ADDENDUM NO. 3

RE: Architect's Project #: 2301 A1

Project: **Bandera County Visitor Center
Phase 2 – Historic Stabilization**

4 SECTION DETAIL
1 1/2" = 1'-0"

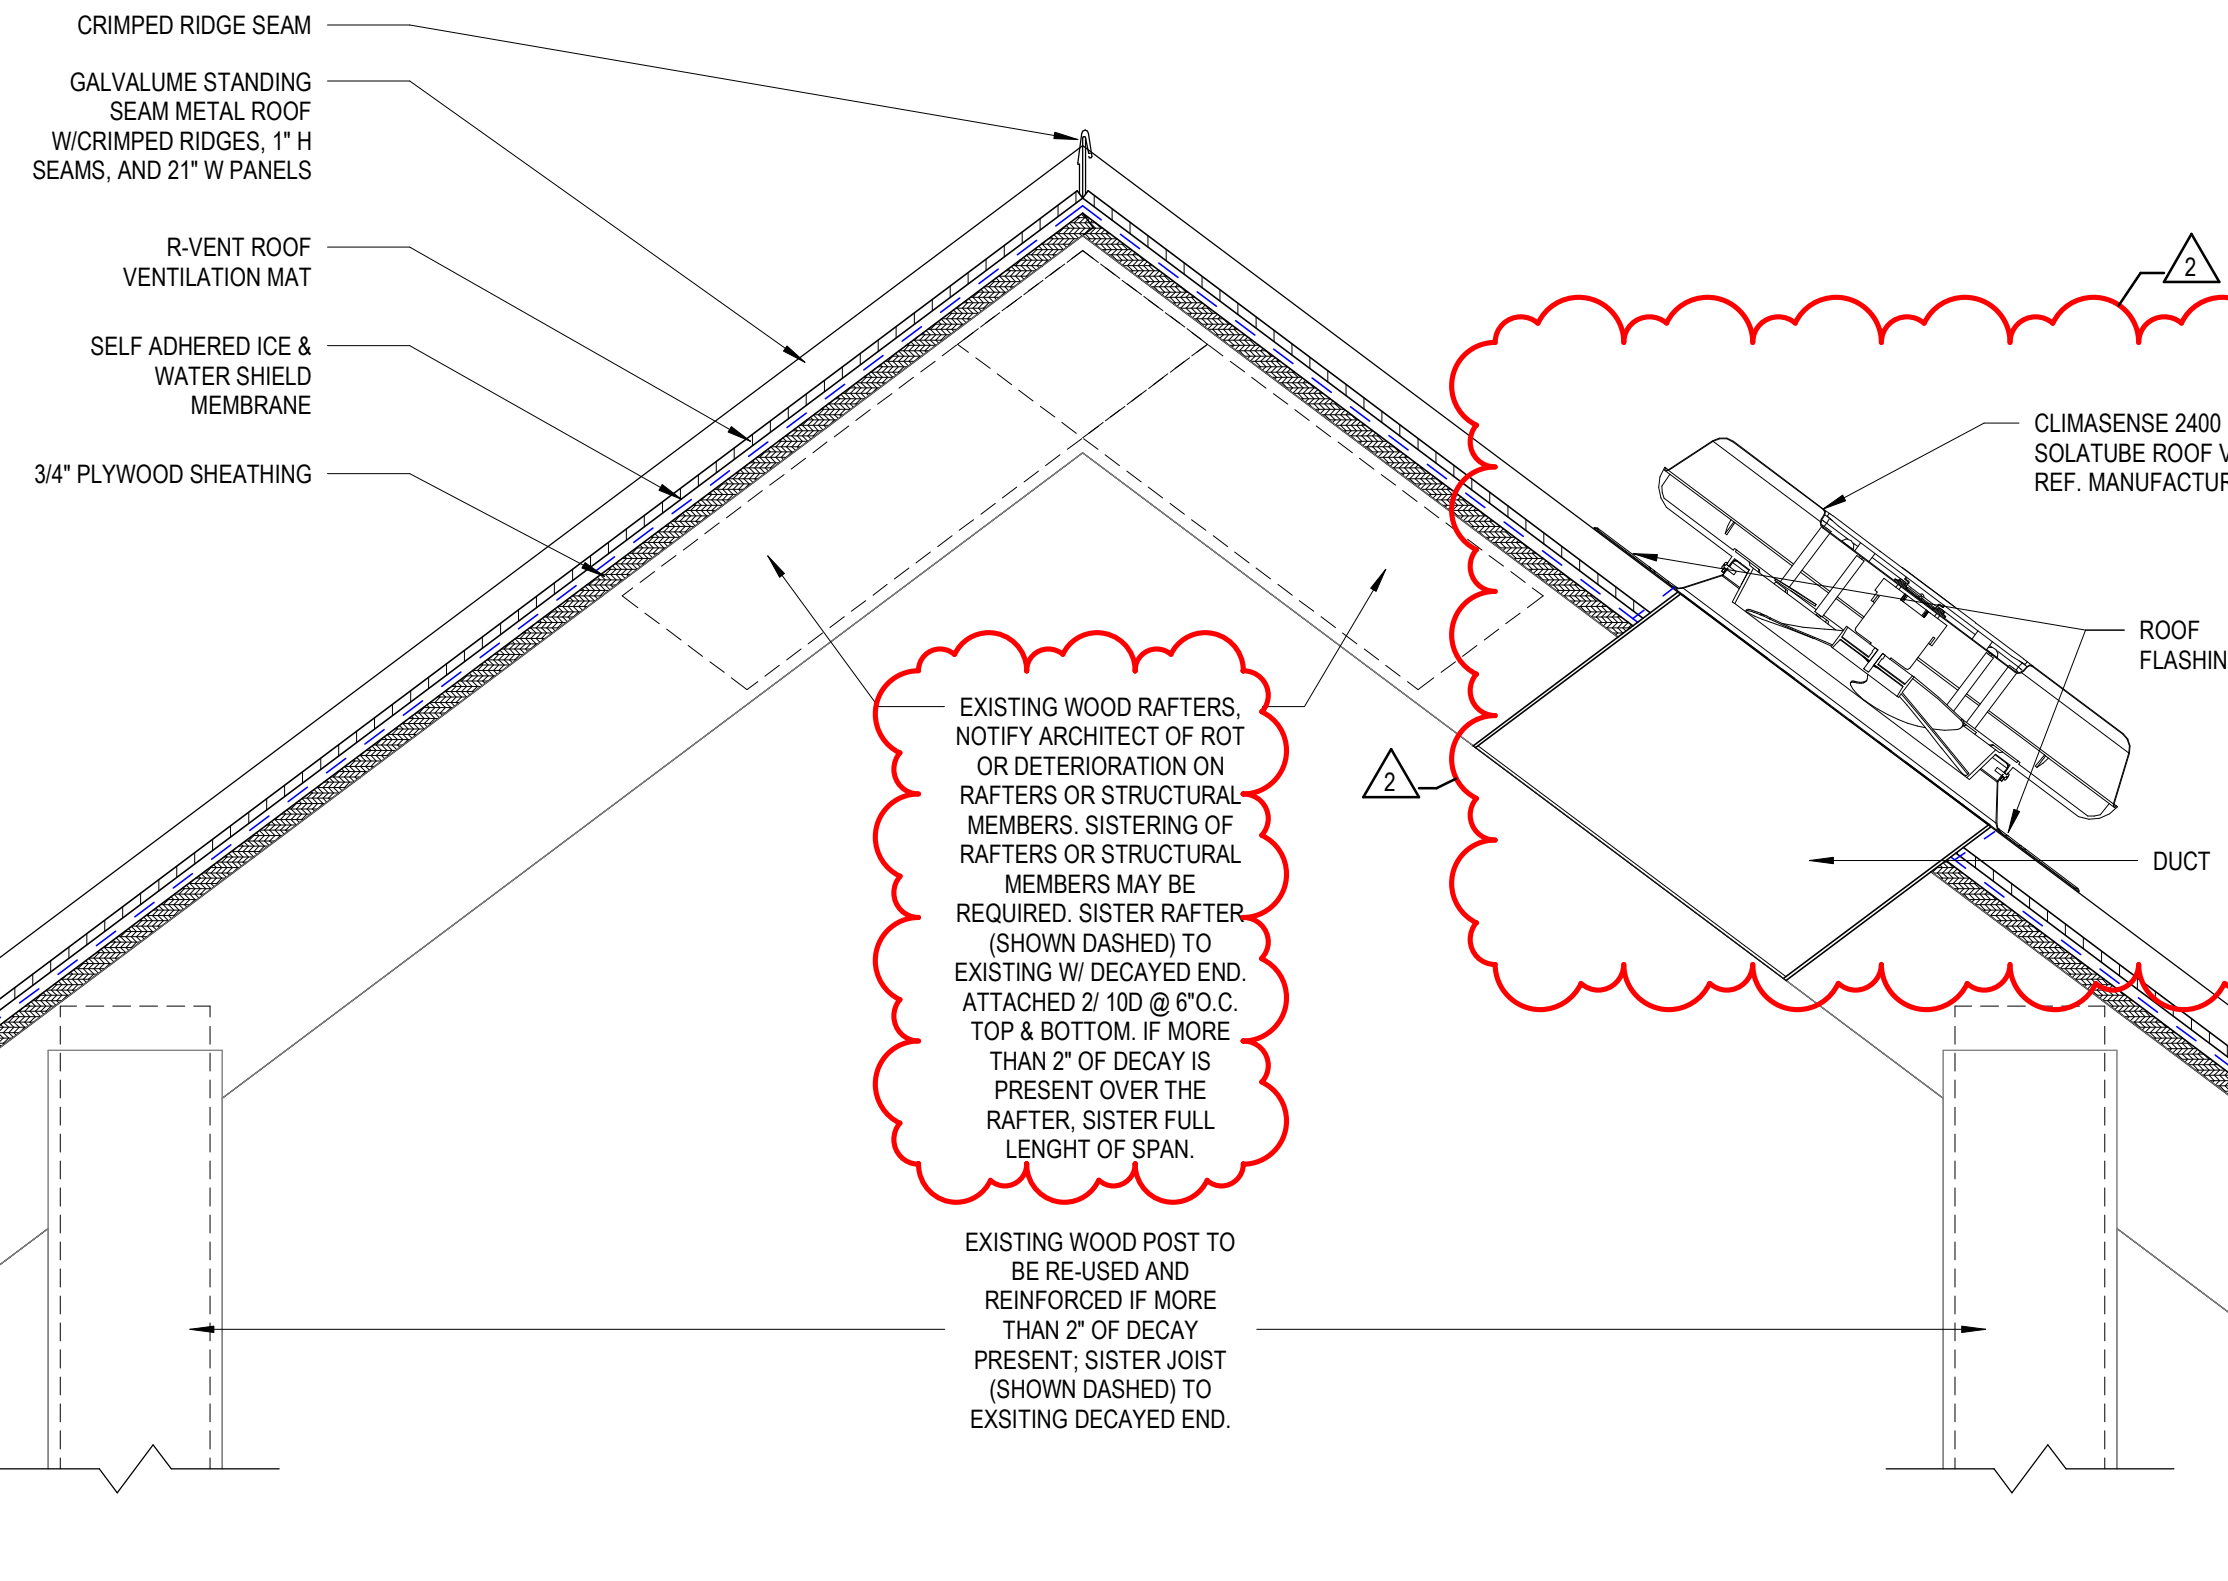
- c. Added solar powered roof vent to details 1 and 4
 - d. Clarified sistering note on detail 4
 - e. Clarified thru wall flashing note and added images to detail 5.

3. For the rafter replacement or sistering is there a spec or engineered requirement?
[Refer to Wood Framing Notes on Sheet A-101 for details.](#)
4. Detail 2/A-101 indicates to install ¾" plywood decking directly to the existing wood rafters. What grade of plywood is required?
[Refer to Wood Framing Notes on Sheet A-101 for details.](#)

5. Detail 2/A-101 indicates to install ¾" plywood decking directly to the existing wood rafters. It is assumed this decking must transfer diaphragm lateral loads to the rafters and resist uplift loads, however, no fasteners are specified. Will the client please provide the required fasteners to resist wind lateral and uplift loads?
[Refer to Wood Framing Notes on Sheet A-101 for details.](#)

6. The drawings do not include any details for fastening the existing rafters to the existing masonry walls to transfer wind lateral and uplift forces. Please confirm the contractor is not required to install any new fasteners or connections at the rafter-to-wall intersections.
[Refer to Wood Framing Notes and Nailing Schedule on Sheet A-101 for details.](#)

9. Please advise if R-Vent Roof Ventilation Mat by Advanced Building Products would be acceptable.
[No](#)
10. Can you please advise if the vent membrane may be removed from the scope due to the crimple ridge – or if there is a different method intended to vent the roof. The crimped ridge will not allow for the venting membrane to function as intended.
[The vent membrane must remain. Please refer to detail 4/A-101.](#)

- WF-1 LUMBER SHALL CONSIST OF DOUGLAS FIR, KILN DRIED W/ A MOISTURE CONTENT OF 19% MAXIMUM AT THE TIME OF INSTALLATION, UNLESS NOTED OTHERWISE.
- WF-2 ROOF SHEATHING SHALL BE 5/8" EXTERIOR PLYWOOD OR OSB OVER WOOD JOISTS. PROVIDE ADEQUATE BLOCKING, TONGUE AND GROOVE EDGES OR PLYCLIPS (2 FOR 48" SPAN), USE 10d NAILS (1/2" PENETRATION) AT 6" O.C. AT END JOINTS.

CONNECTION	NAILING	LOCATION
1. CEILING JOIST TO PLATE	(3) 8d COMMON	TOENAIL
2. CEILING JOIST, LAPS OVER PARTITIONS	(3) 16d COMMON	FACENAIL
3. CEILING JOIST, TO PARALLEL RAFTERS	(3) 16d COMMON	FACENAIL
4. RAFTER TO PLATE	(3) 8d COMMON	TOENAIL
5. COLLAR TIE TO RAFTER	(3) 10d COMMON	FACENAIL
6. ROOF RAFTER TO 2x RIDGE BEAM	(2) 16d COMMON	TOENAIL
	(2) 16d COMMON	FACENAIL

11. Re: 5/A-101: Please provide more detail at top of chimney. If this chimney is to be functional, there is a concern over wood being exposed to the smoke/heat as shown. Framing is not clear as to provide for ventilation. Flashing details are also not clear (re: extent of waterproofing, through wall flashing).

- Chimney will not be functional. Refer to detail 5/A-101 for clarification on flashing detail.
12. Is the through wall flashing at chimney, indicated by blue dashed lines, existing? If required to be new, is the through wall portion to be at roof side only? If required, is there a specified level or distance (above roof, below cap or stone course) that through wall is to be achieved? Is material to match galvalume metal specified at roof flashing?
The blue dashed line indicates new through wall flashing that is to be applied only to the roof side of the wall, refer to detail 5/A-101 for clarification on how to install. Flashing to match galvalume metal specified at roof.

4 SCUPPER DETAIL
1" = 1'-0"

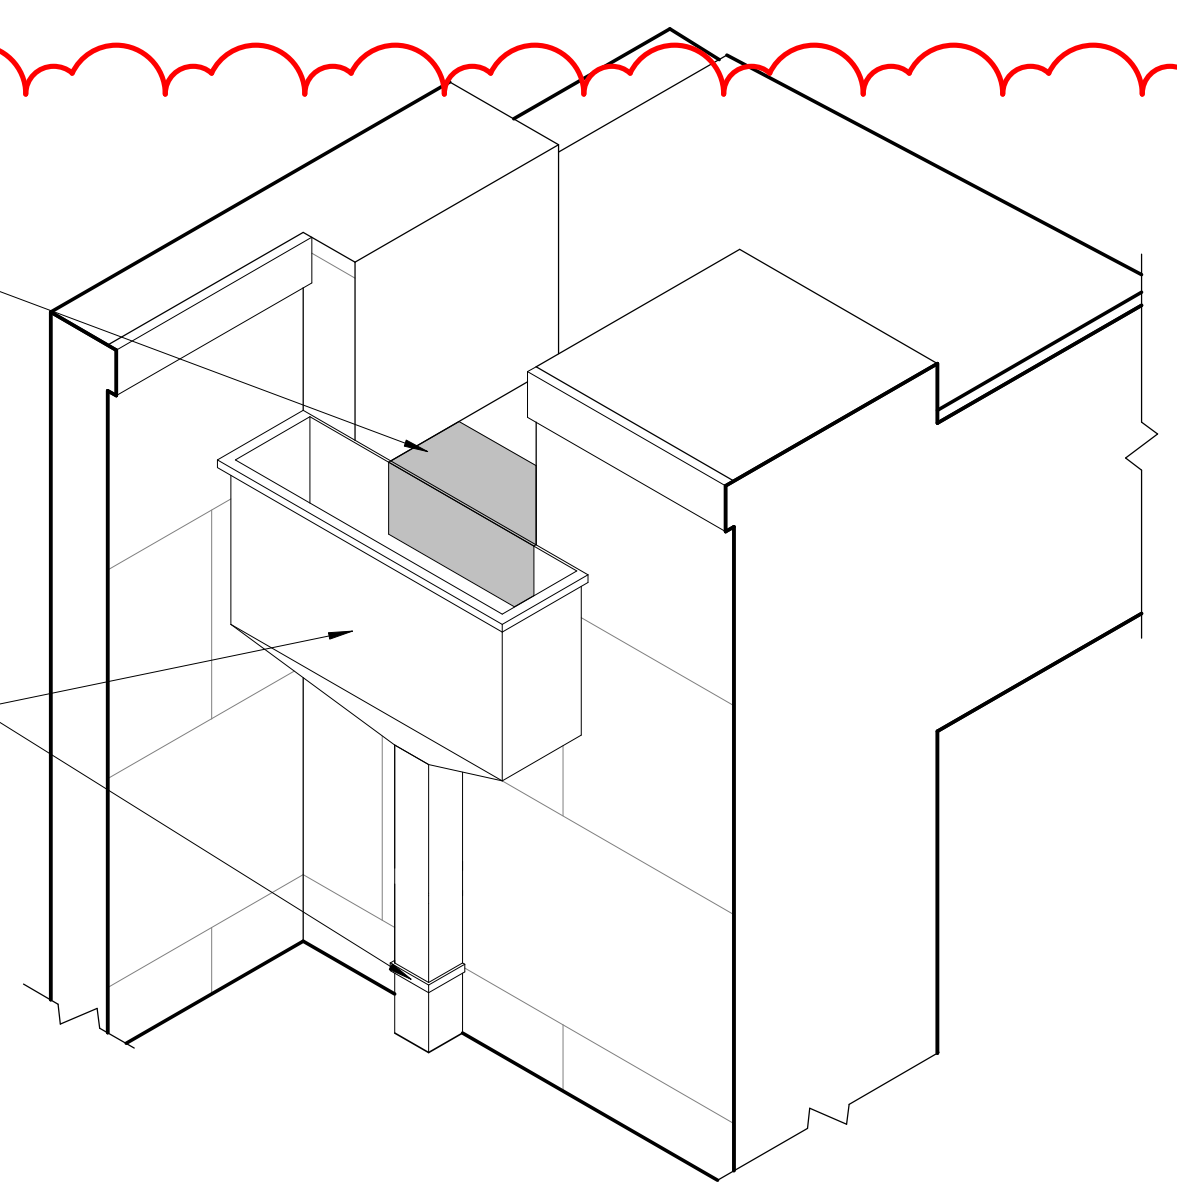
- b. Keynote 12 has been added to secure opening at jail holding area.
 - c. Detail 4 has been added to clarify scupper work.
6. **Sheet A200** – The following changes have been made to the sheet:

16. There is no roof work being done on the jail other than replacement of the scupper and downspout, is that correct? If so, what is the roof material type and brand existing so we know how the tie-in will need to be done?
Correct, refer to detail 4/A-110 for information on the tie-in of scupper to existing roof.

ADHERE TPO MEMBRANE OVER THE EXISTING ROOF MEMBRANE INTO THE NEW SCUPPER

NATURAL FINISH GALVALUME SCUPPER AND 6" DOWNSPOUT W/ OVERFLOW DRAIN; ANCHOR DOWNSPOUT THROUGH THE MORTAR

NO WORK ON EXISTING ROOF PROTECT DURING SCUPPER INSTALLATION

1 1877 COURTHOUSE-REHABILITATION-EAST ELEVATION
1/4" = 1'-0"

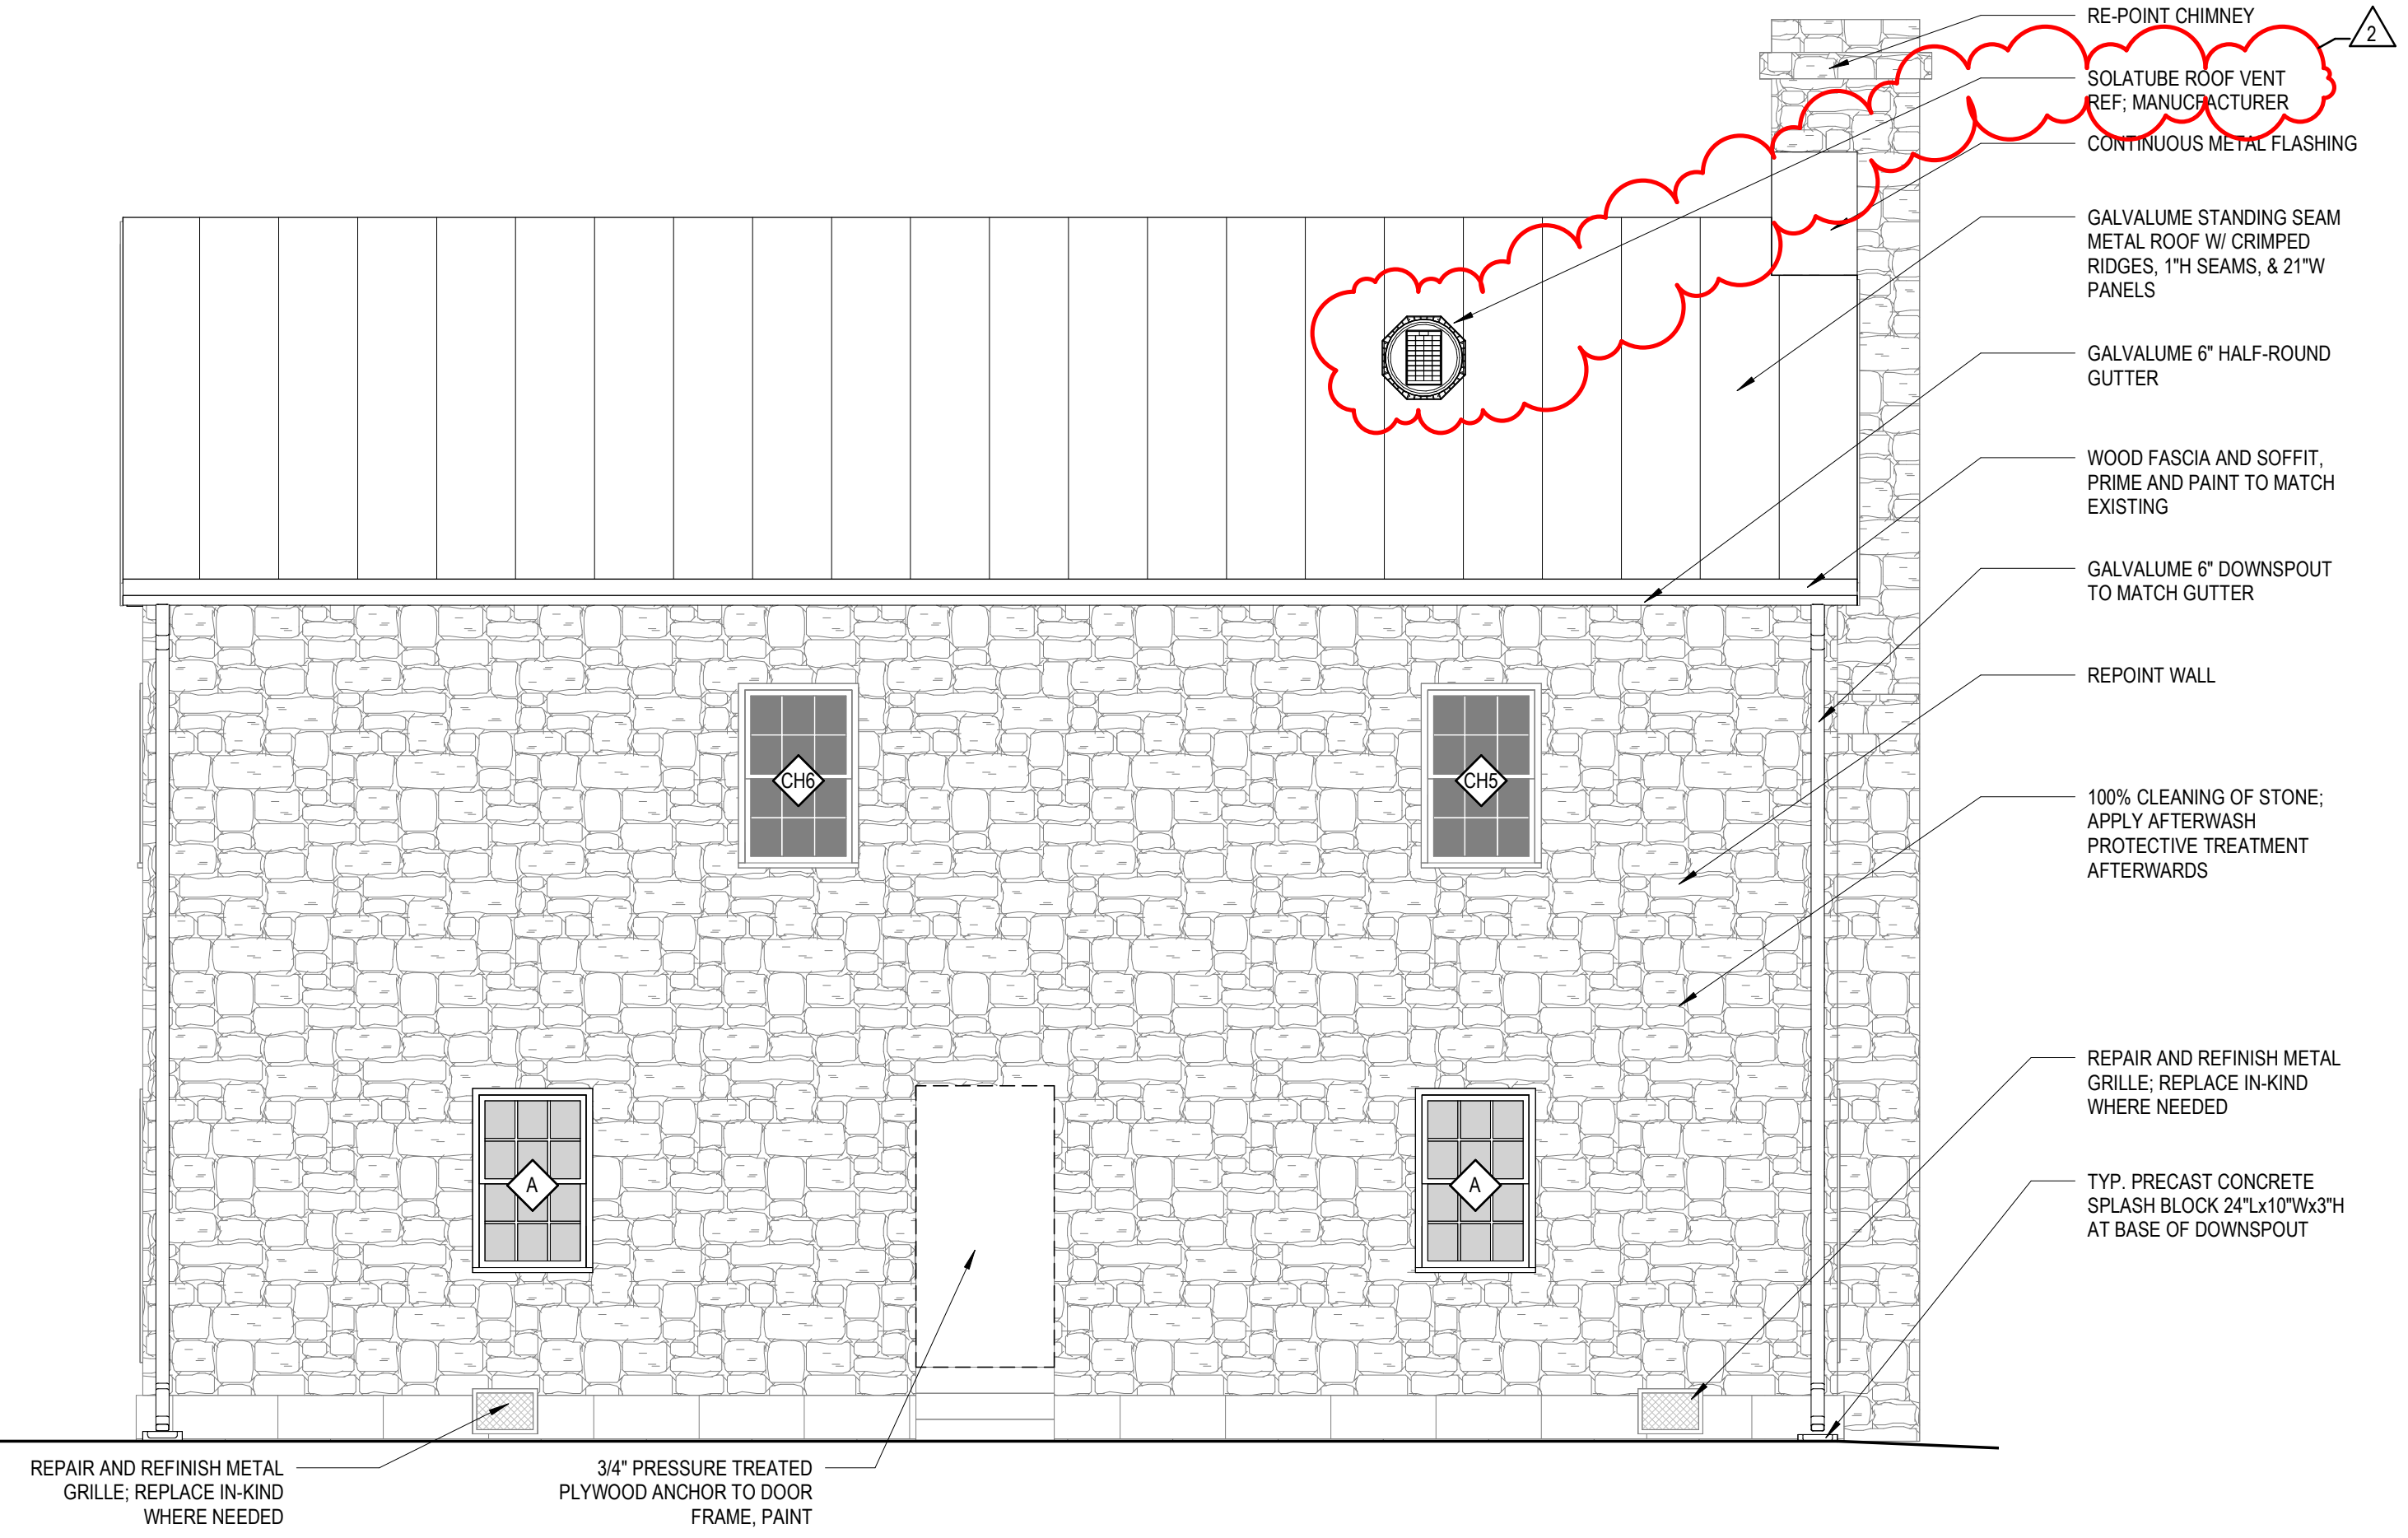
- a. Added solar powered roof vent to east elevation.
 - b. Removed note for tree limbs.
 - c. Added note for door protection on west elevation.
7. **Sheet A201** – Added solar powered roof vent to elevations.
